**CITY OF BATON ROUGE
PARISH OF EAST BATON ROUGE**

ADDENDUM NO. 2

**SUBJECT: MALL OF LOUISIANA BOULEVARD
(RR BRIDGE AND PUMP STATION)**

CITY-PARISH PROJECT No. 12-CS-HC-0043D-1

SHEET NUMBER	473
PARTIAL	EAST BATON ROUGE
CONTROL SECTION	BATON ROUGE
STATE PROJECT	12-CS-HC-0043
DESIGNED BY	UNDESIGNED
DRAWN BY	UNDESIGNED
CHECKED BY	UNDESIGNED
DATE	5/12/25
REVISION OR CHANGE ORDER DESCRIPTION	ADDED SUPPORT BAR BOLT DETAILS & NOTES
BY	UBJ
DATE	5/12/25

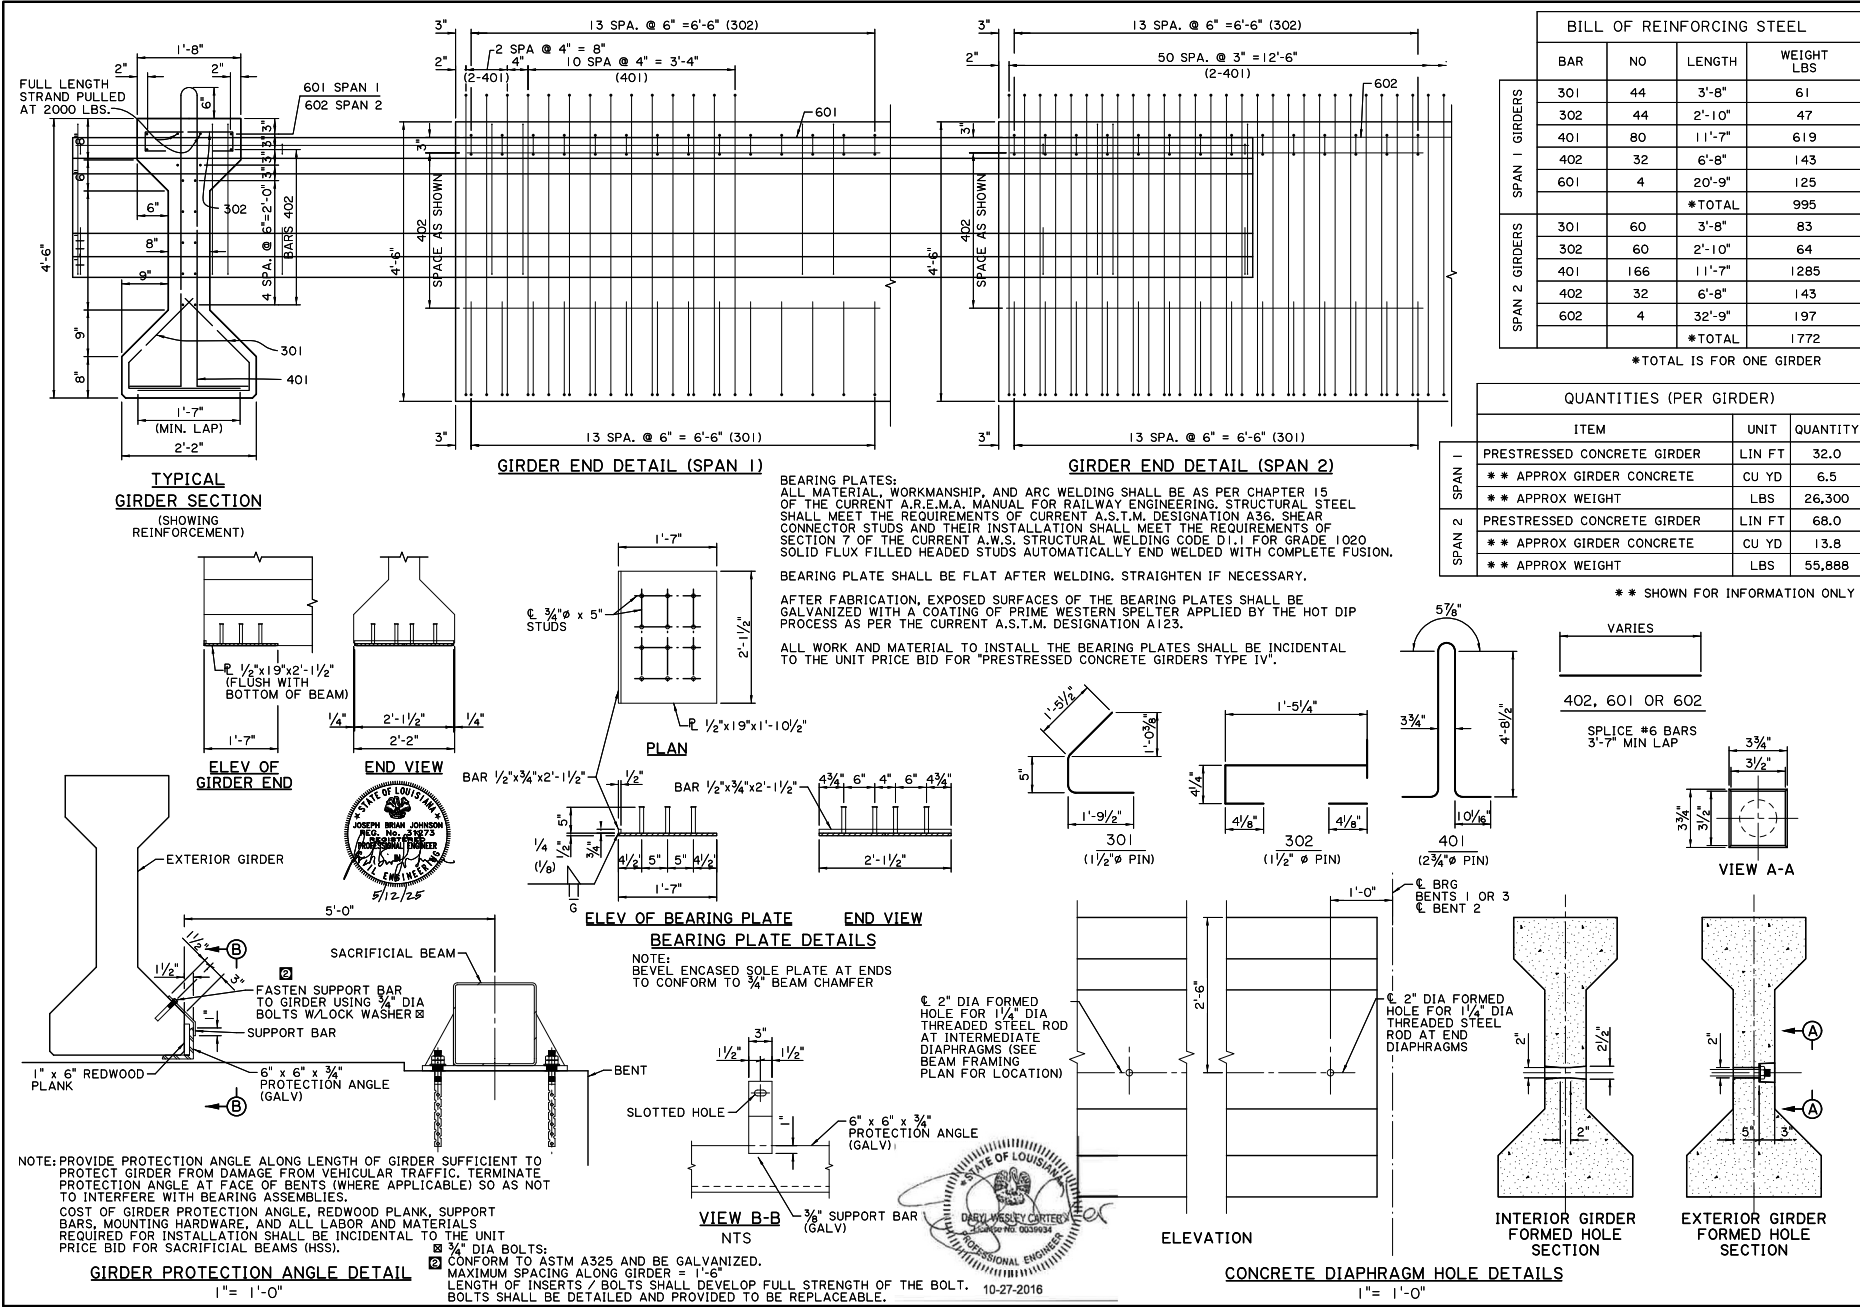
Replace Plan Sheet 473, entitled Kansas City Southern Railway 100% Submittal KCS Bridge Underpass Type IV Girder Details (2 of 2), with the attached Plan Sheet 473. Revised 5/12/2025. (Attachment D).

On sheet 473, the girders show fastening the support bar to the girder using $\frac{3}{4}$ " bolts with lock washers. Please provide detail on type and spacing for the fasteners to be casted into the girder.

See revised plan sheet included in this addendum.
